Agenda Item: RP545 Revision 1

Title: Revision 1 for API RP545 **Recommended Practice for Lightning Protection of Aboveground Storage Tanks for Flammable or Combustible Liquids**

Date: July 21, 2012

Proposal: New text is red underlined

Figure A.2—Components of Typical Negative Cloud-to-ground Lightning Stroke

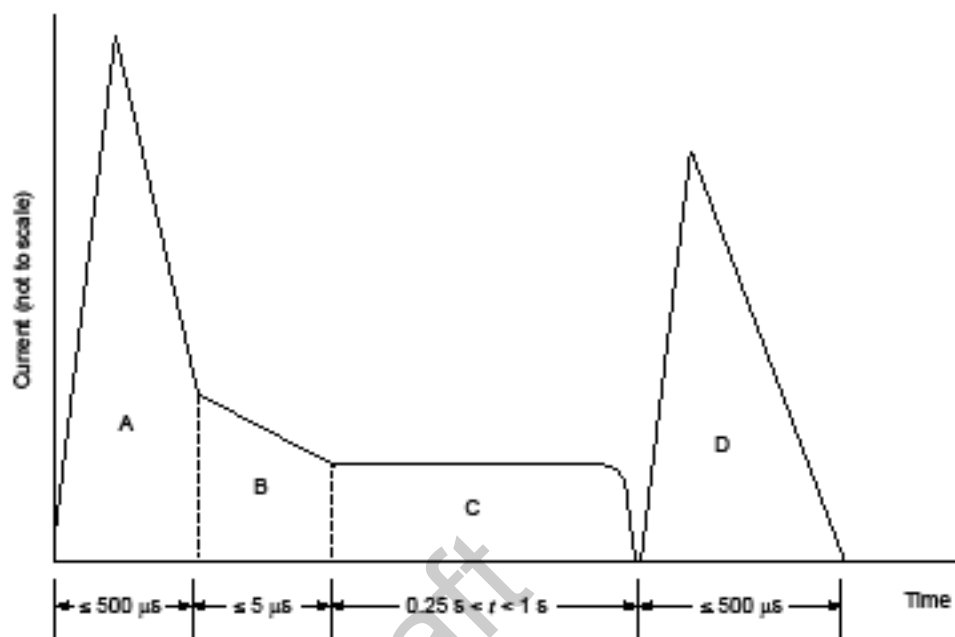
ED NOTE: "B" in tables A.1&2 should be corrected to 5 ms (milliseconds, not microseconds)
